GIRDWOOD TRAILS PLAN

PUBLIC MEETING

NOVEMBER 19, 2020

GTP Public Presentation edits/comments received from GTP Subcommittee members

GIRDWOOD TRAILS: PHYSICAL CONDITIONS

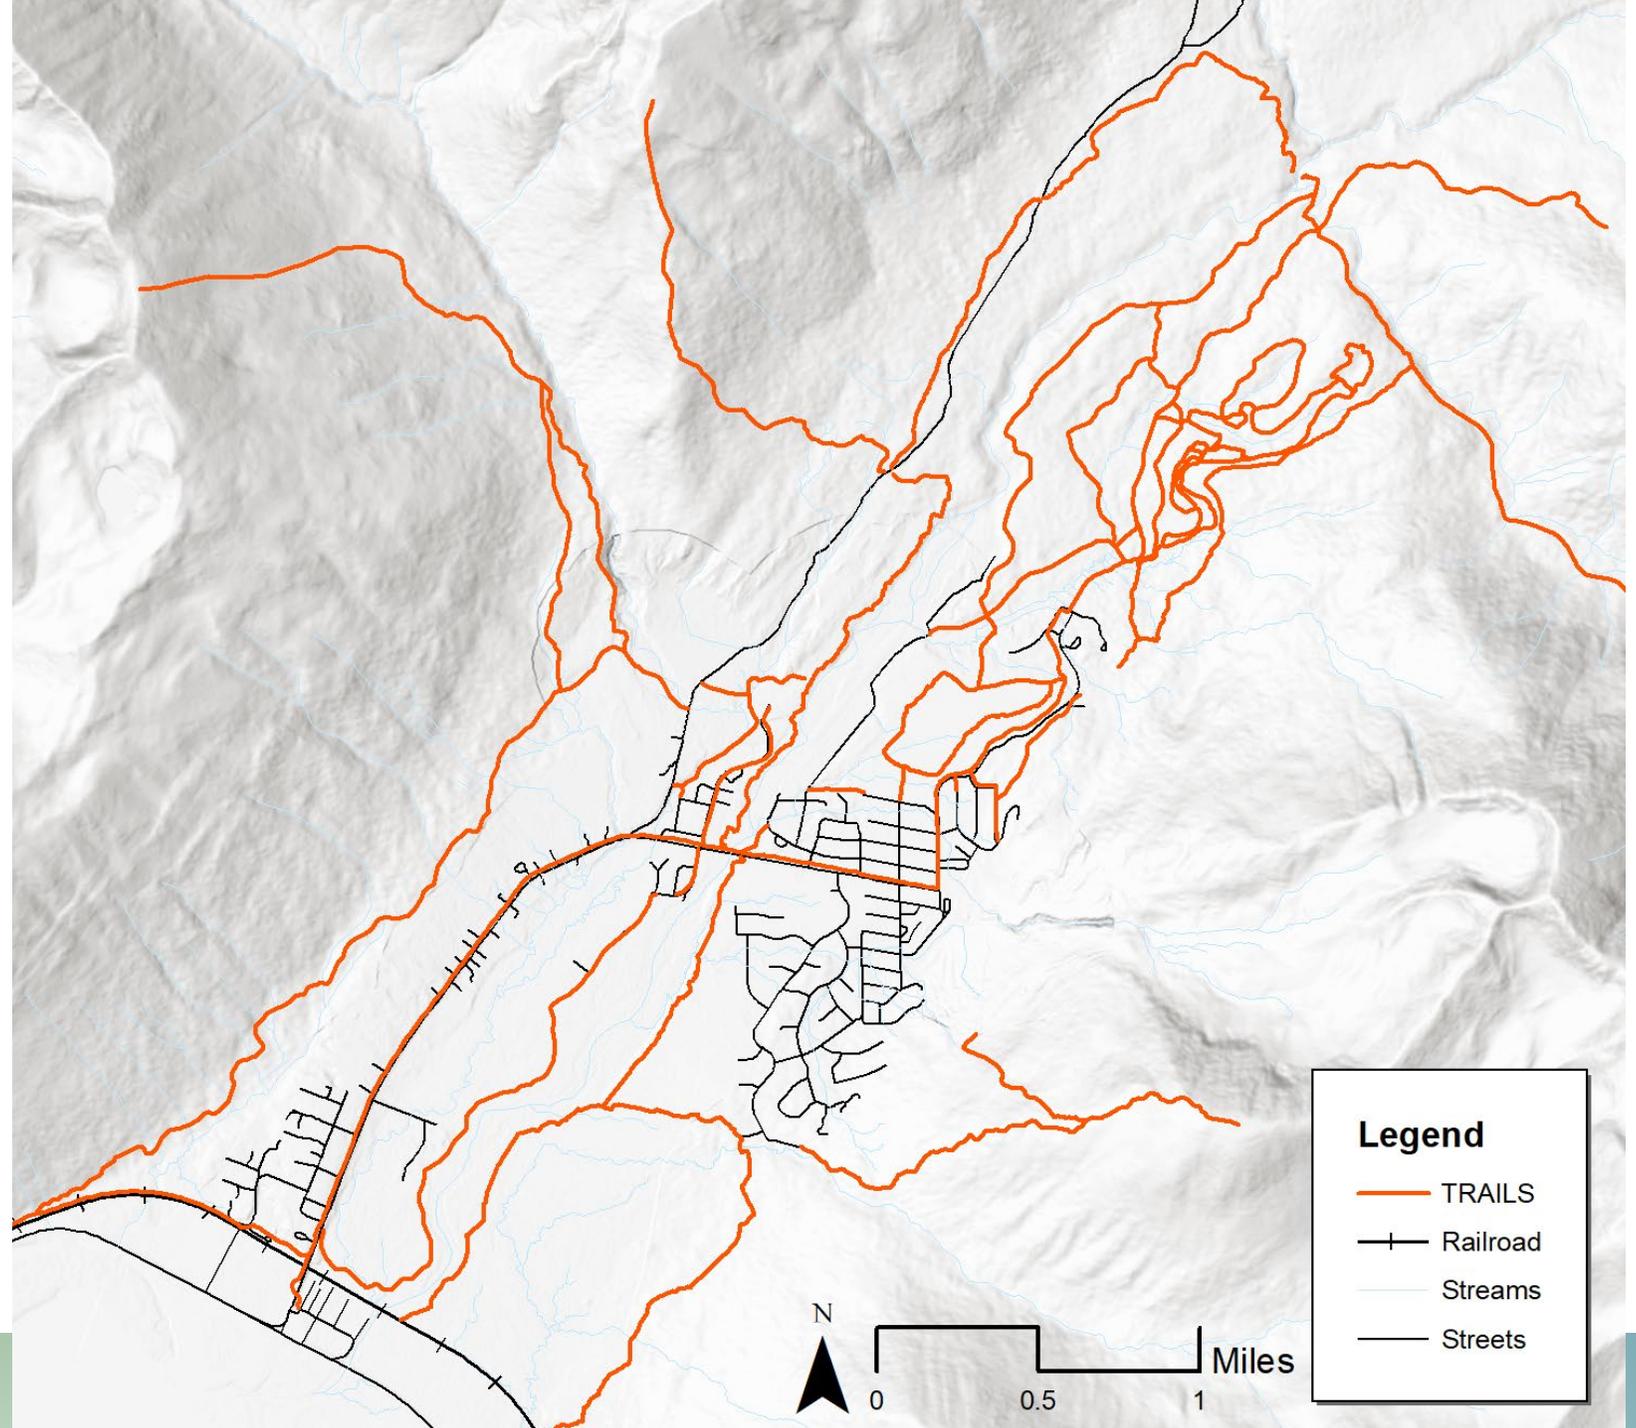
- E. Slide 8:
 - 1. Revise second bullet to: "The Girdwood trail and natural spaces system has the structure, potential, and prime location of a world-class system; with intentional planning, designation and protection of natural spaces, building and protecting of trails, and adding connections and signage, a more cohesive experience can be created."

- 2. Add another bullet after the first two: "Existing de-facto and designated natural spaces provide valuable ecosystem services and opportunities for recreation, quiet, meditation, adventure, and wildland experiences."

- 3. Revise last bullet to: "While natural beauty and opportunity for recreation are abundant in Girdwood, there are some physical constraints and considerations to take into account for trails and natural spaces. This includes: factors impacting construction and sustainability of trails, and environmental conditions and factors (e.g. soil, topography, climate) for planning processes and other aspects of trails and natural spaces development and designation."

Page 8 – text heavy but agree with all 4 bullet points

EXISTING TRAILS

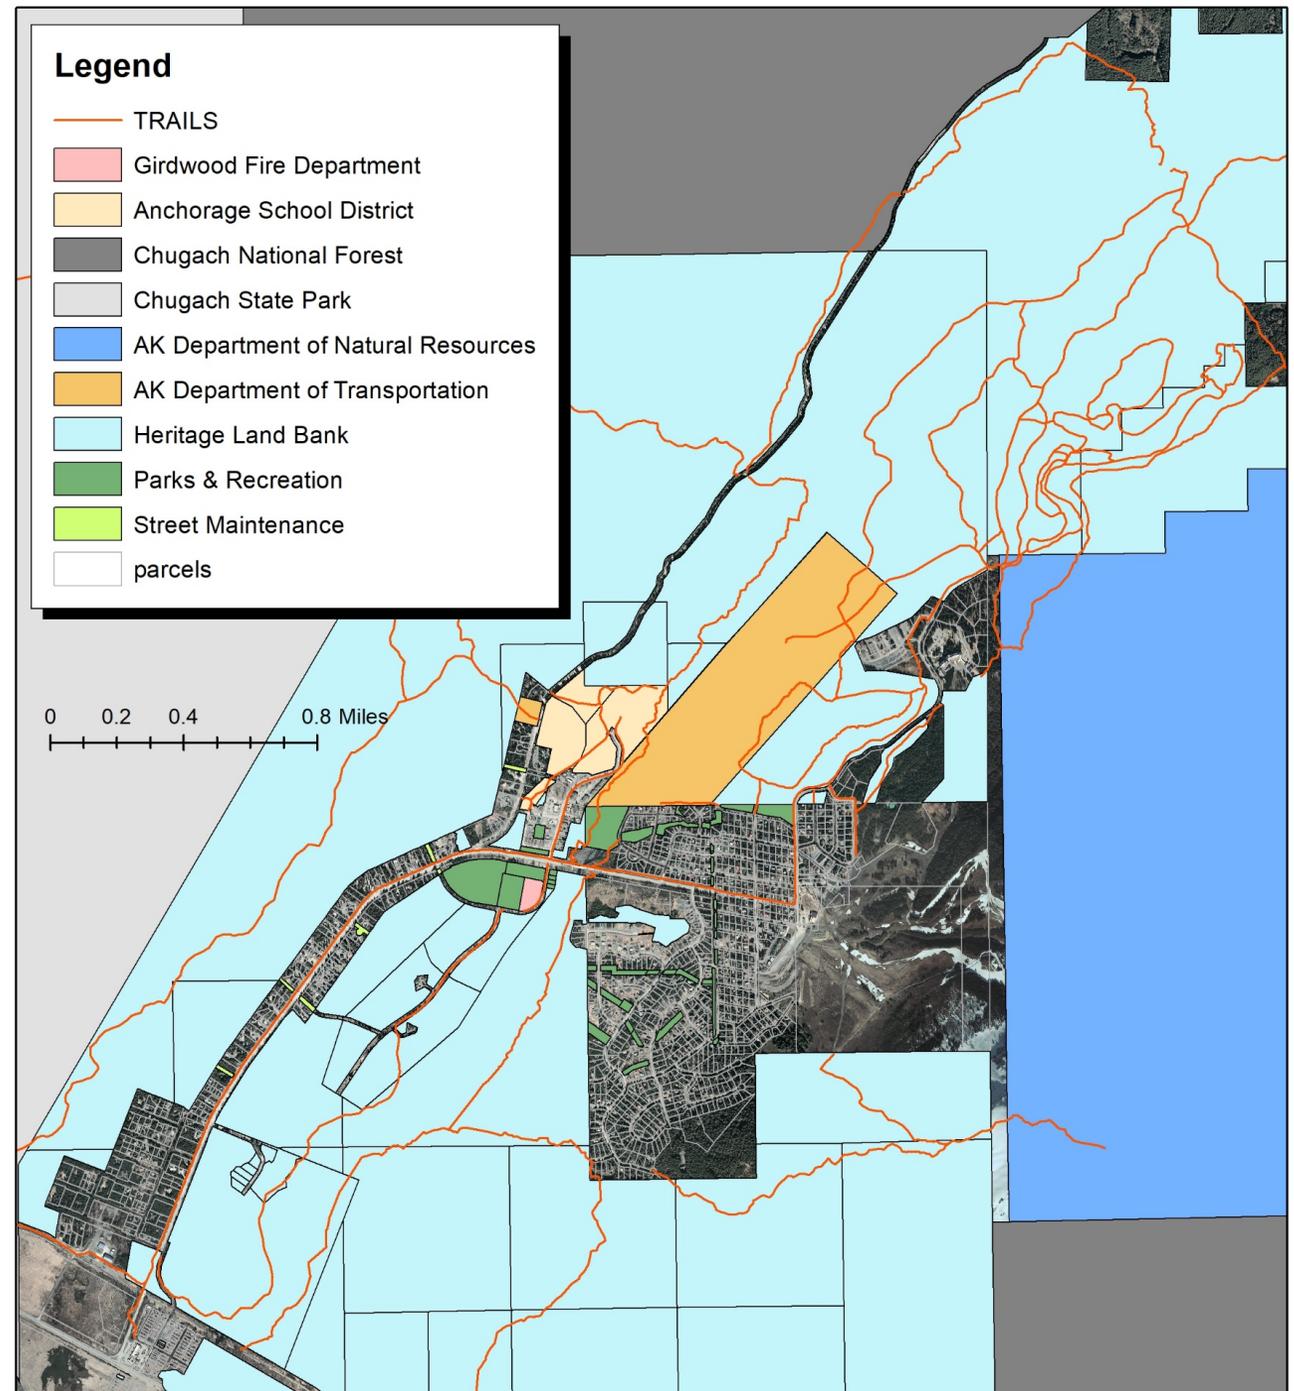
1. Change title to "EXISTING TRAILS AND NATURAL SPACES". If you're going to make edits to the table for trail classes (which I don't think is terribly imperative for the townhall), I'd suggest using what was already in existence prior to this month, as some proposed edits by those working on the Trails Management Plan haven't yet received full public review until next month.
2. I think there could be value in adding a second mini-table on the left for natural spaces. Something like this:

Designated Natural Spaces
Park land - 1 (Moose meadows)
Rustic built and natural - 1 (Hand tram/ Four Corners area)
Primitive/Wild - 0 (currently only de- facto; needs designation work; 2 currently proposed: Virgin Creek area and Stumpy's Trails area)

Page 11 – absolutely need to use this data to help make decisions about future goals (ie. If there is a lack of class 4 in the valley, than a future objective should be to add more class 4 trails or improve a class 3 to class 4. Open space should not be included here – this is a trails plan and an open space plan is very different

Page 11 We will need to make some corrections on the chart after the meeting. We will need to decide for the plan whether we will upgrade some trails in the future so their numbers will change. Will we list what we will want for known future changes?

CONNECTIVITY

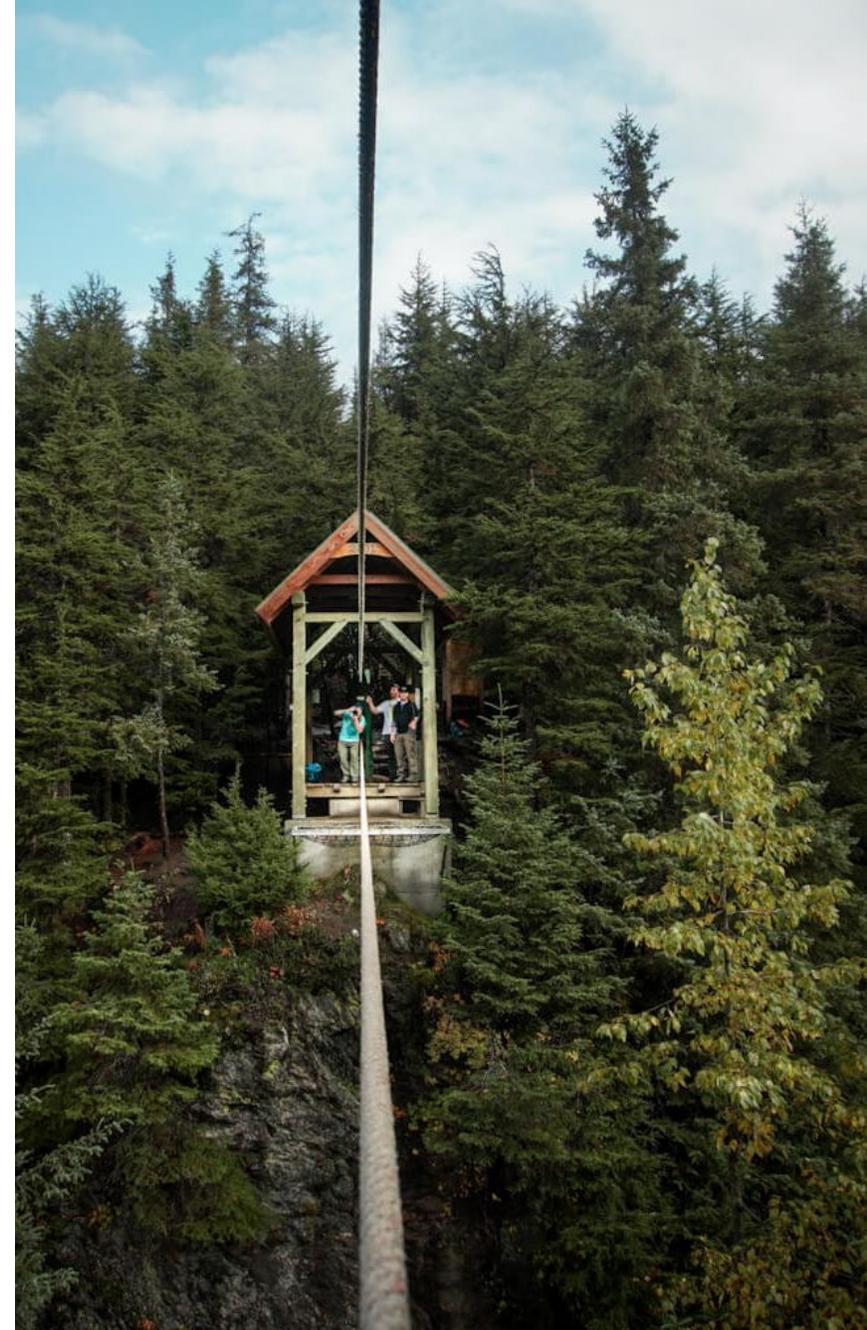
- O. Slide 21: I'd modify the second one since some of them are connected, e.g. the school has the Athabascan Trail and trail connections over to Crow Creek area.

- P. Slide 21: Some fixes:
1. As has been noted previously, this is lacking other proposed future work, especially the proposed future natural spaces development in Virgin Creek and Stumpy's areas. If "future mountain bike park" is going to be noted, so should those be (even moreso because there technically is no 'bike park' - it's just a collection of trail easements).

2. Following on #1 above, I'd recommend not using shaded-in polygons for the bike park and the natural space areas, to be consistent with the rest of the map - I'd recommend just contrasting bolded lettering in the general vicinities, as is done with the 5K usage annotation.
